CANDLEWOOD SUITE HOTEL | CHERRY HILL SWEDISH CAMPUS

PLAN CHANGES FROM 09-11-2019 SAC MEETING - HOTEL PROPOSAL

505 16TH AVE, SEATTLE

L2 -L3 FLOOR PLANS - PROPOSED

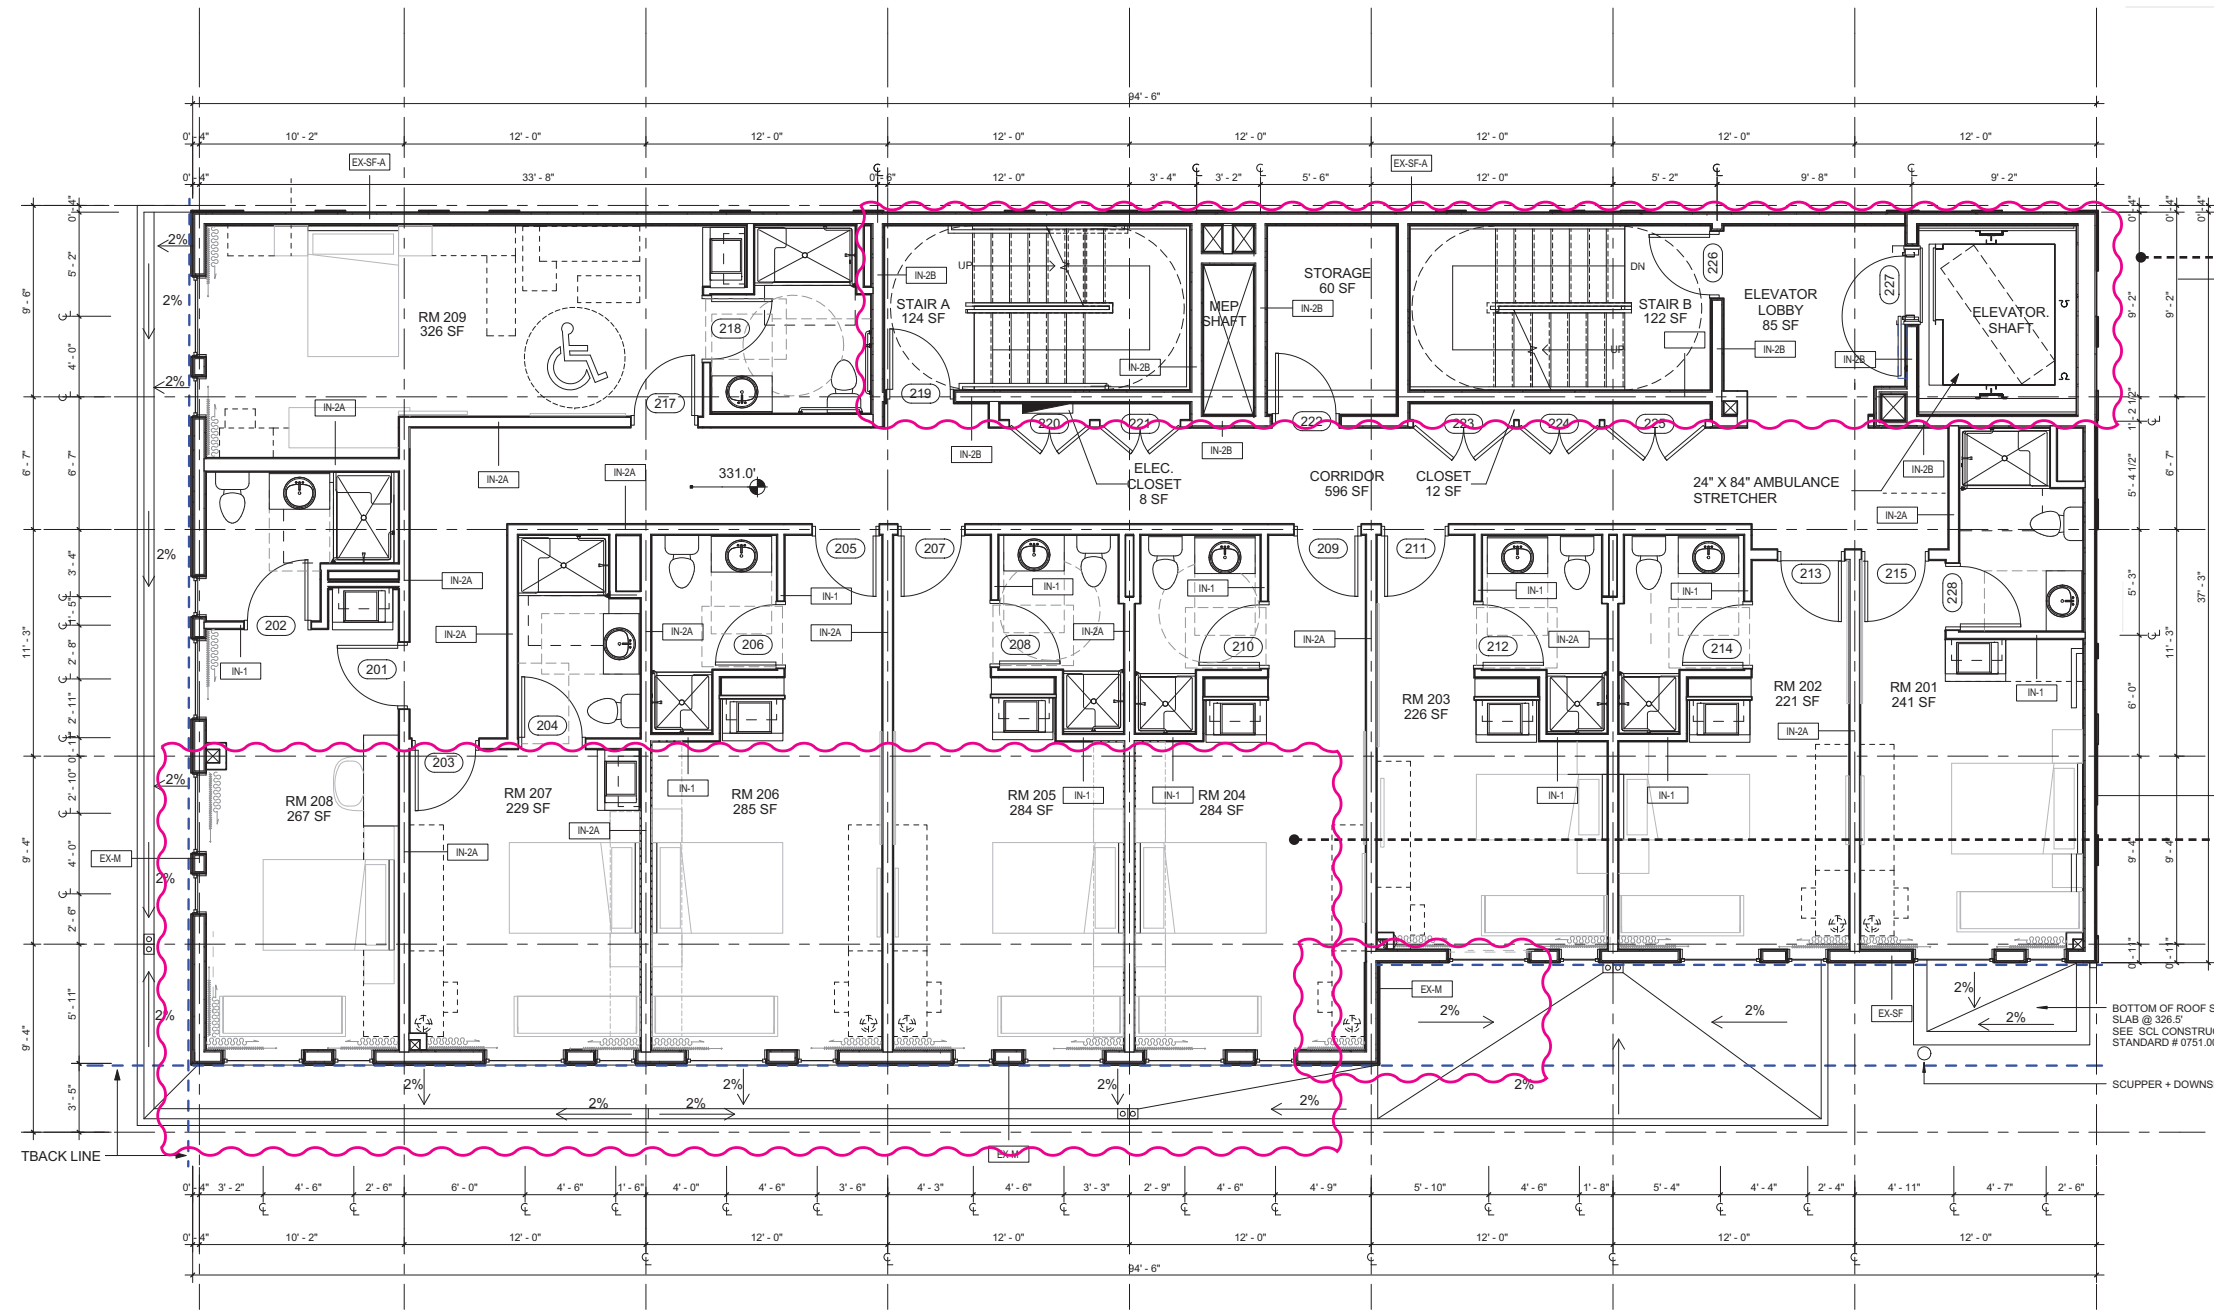
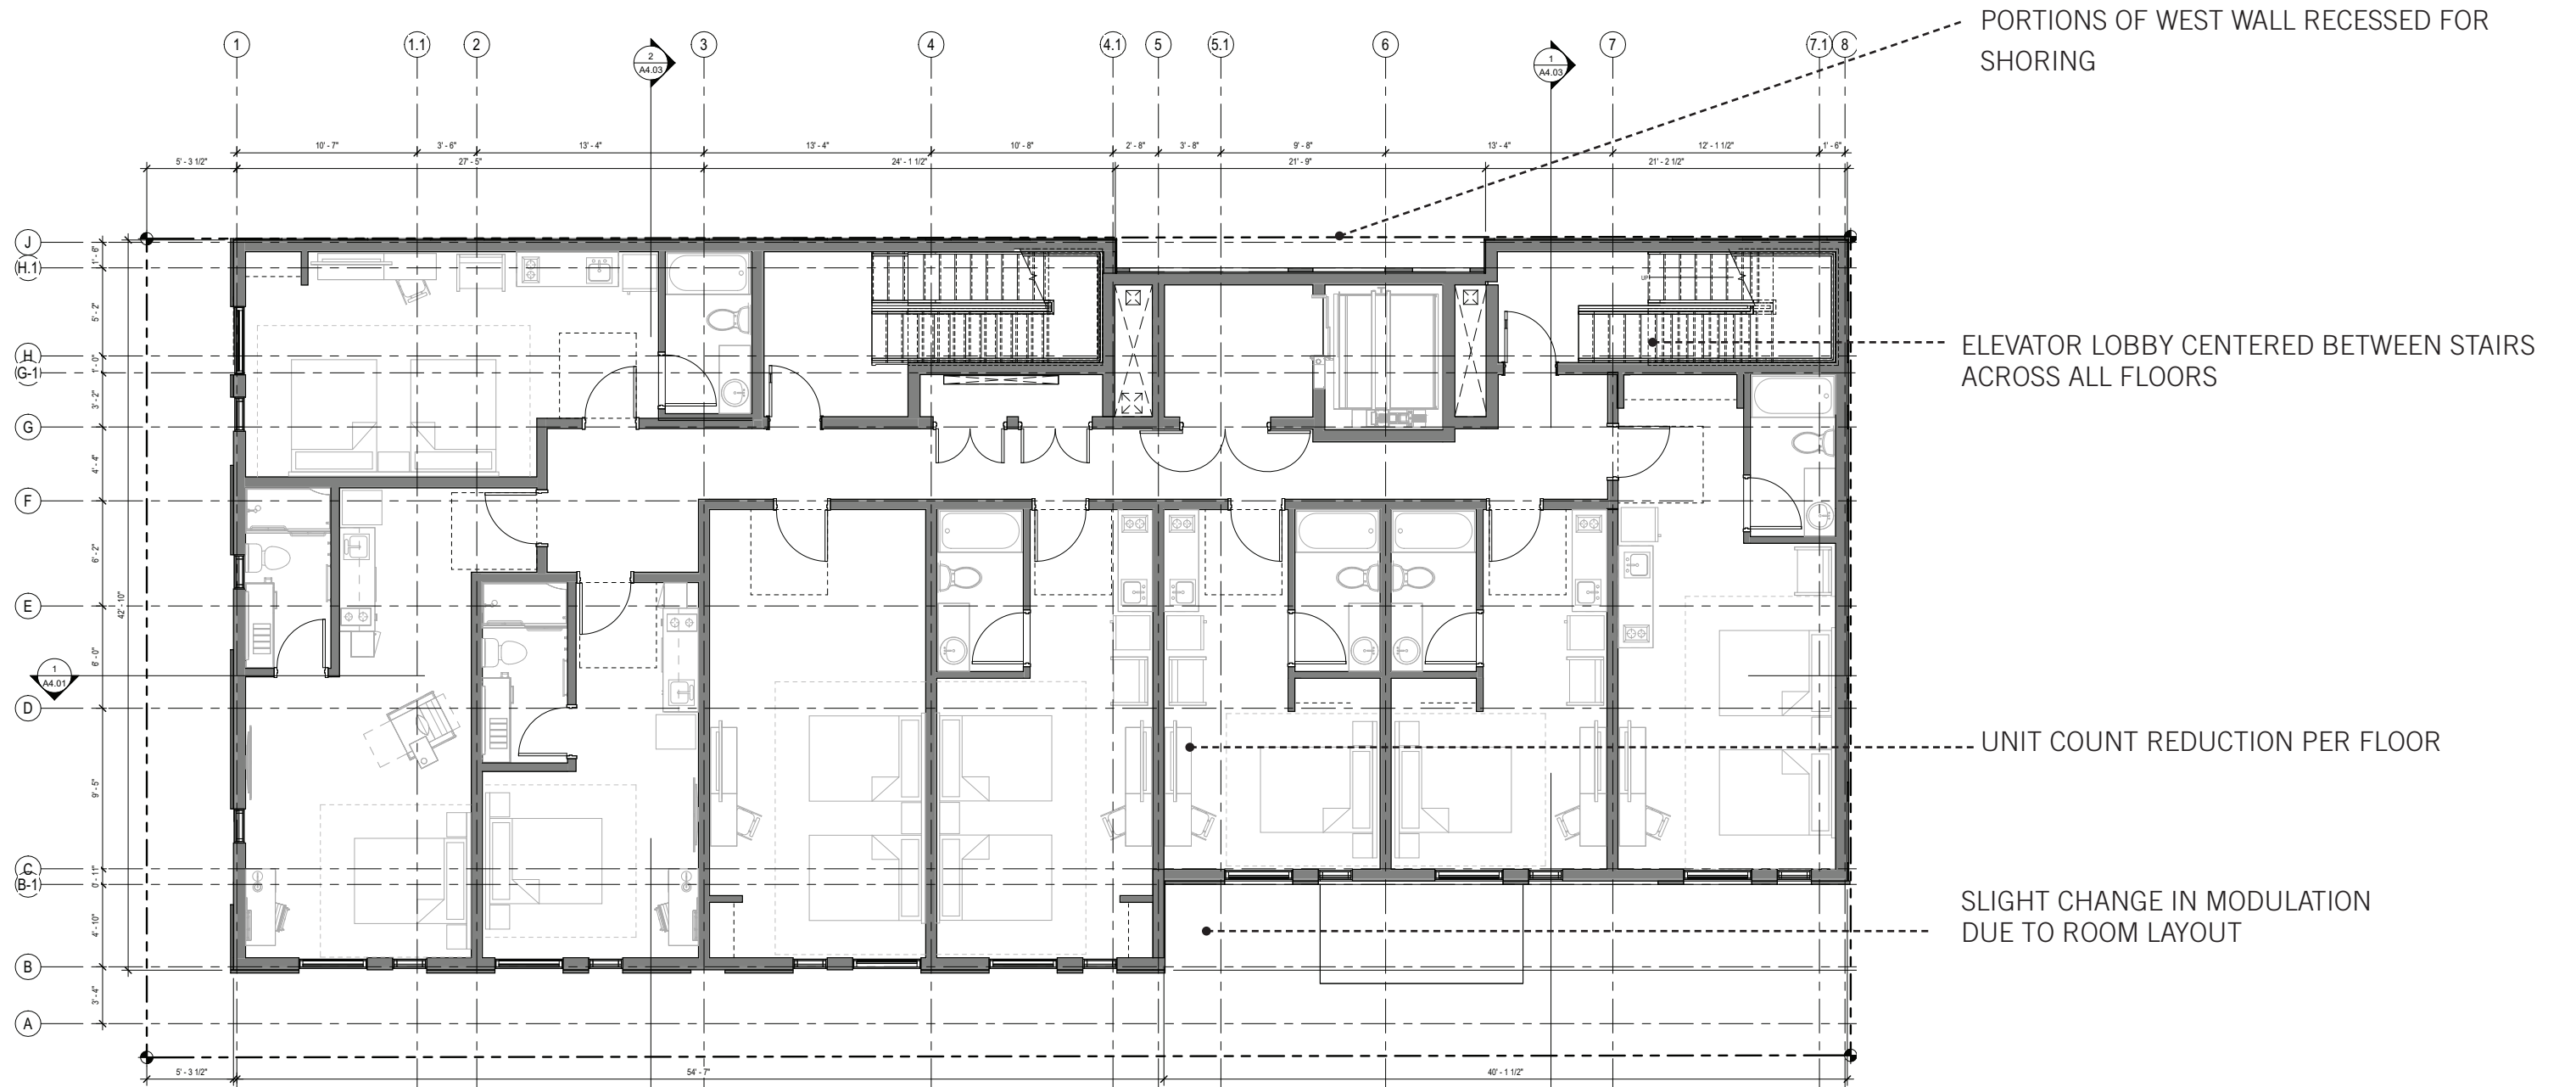
STAIRS AND ELEVATOR AREAS RECONFIGURED

UNIT SIZED AND LAYOUT IS RECONFIGURED TO ADJUST OPERATOR'S BRAND NEEDS AND STANDARDS

L4 FLOOR PLAN - PROPOSED

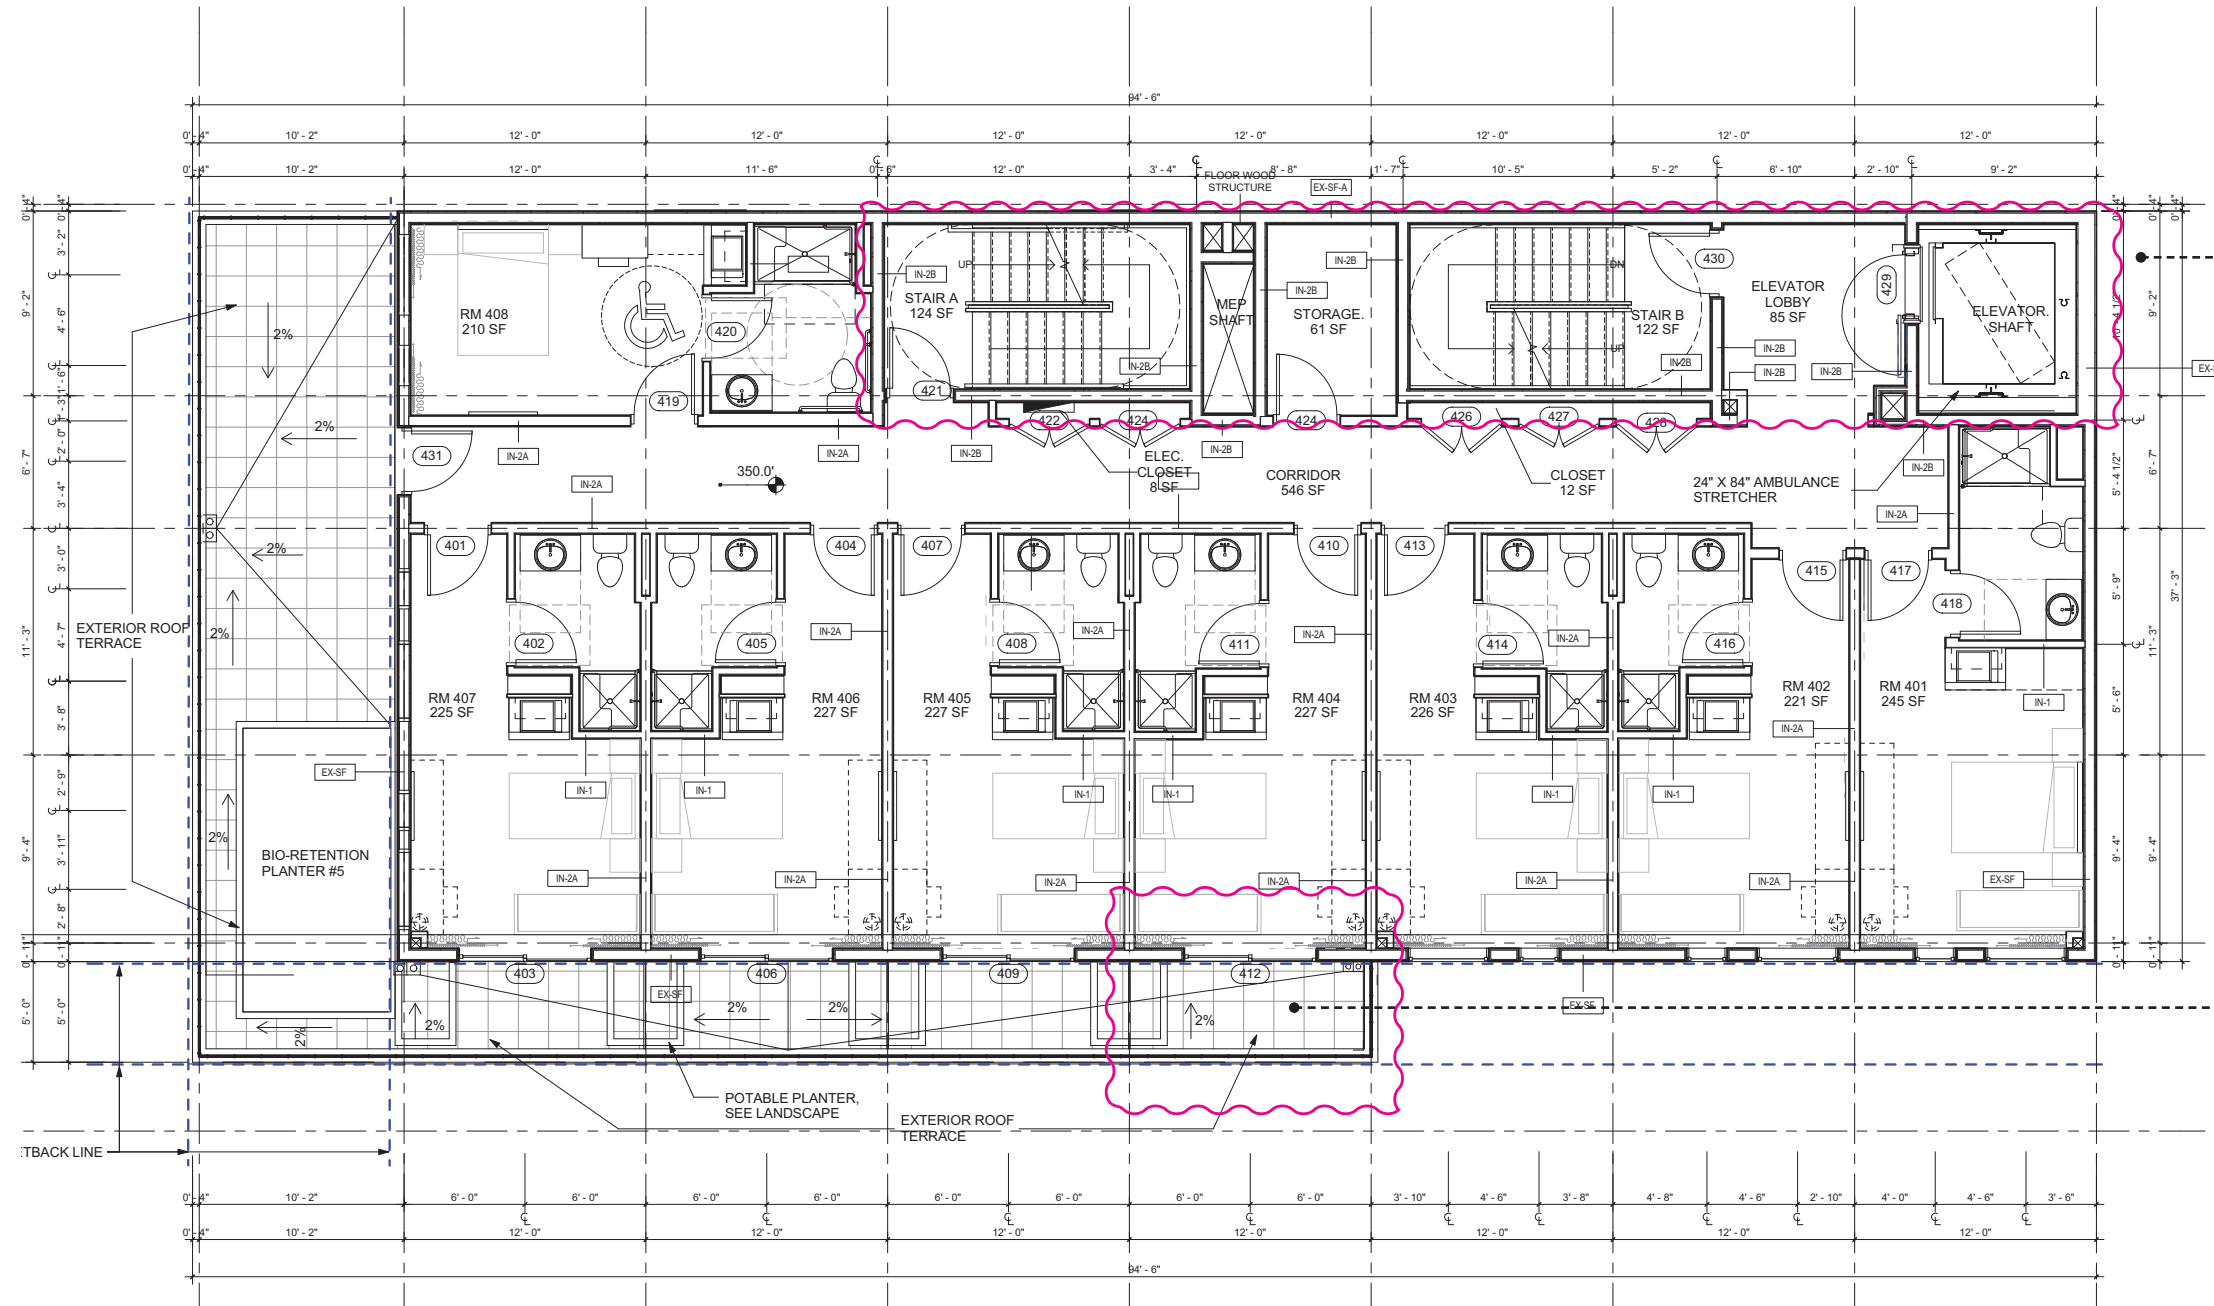
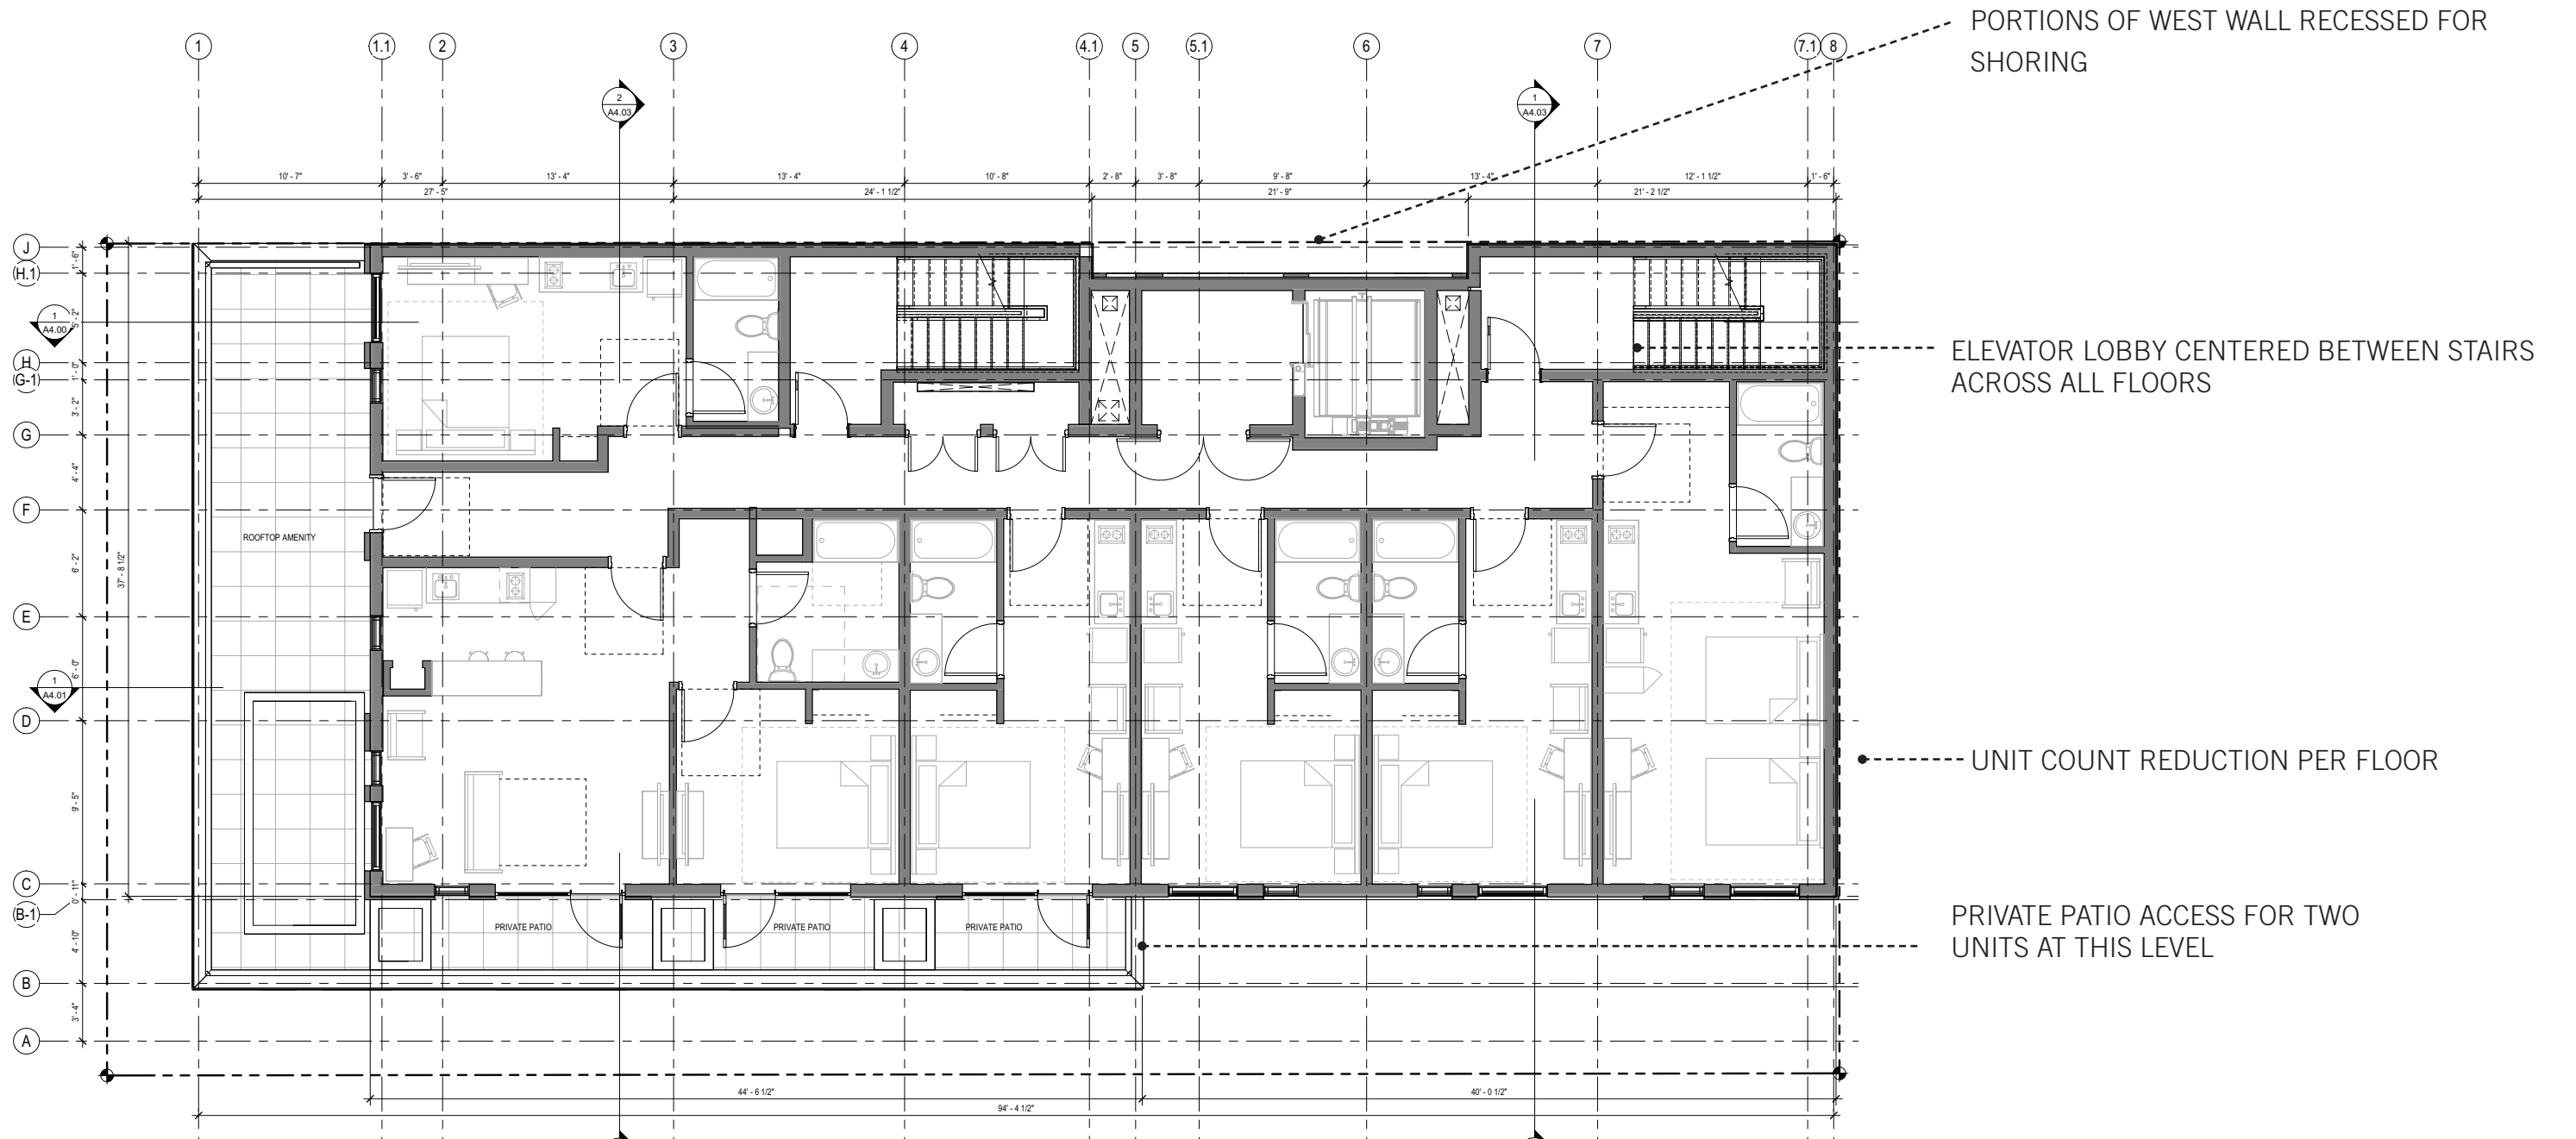
STAIRS AND ELEVATOR AREAS RECONFIGURED

NUMBER OF UNITS WITH PATIO ACCESS REDUCED
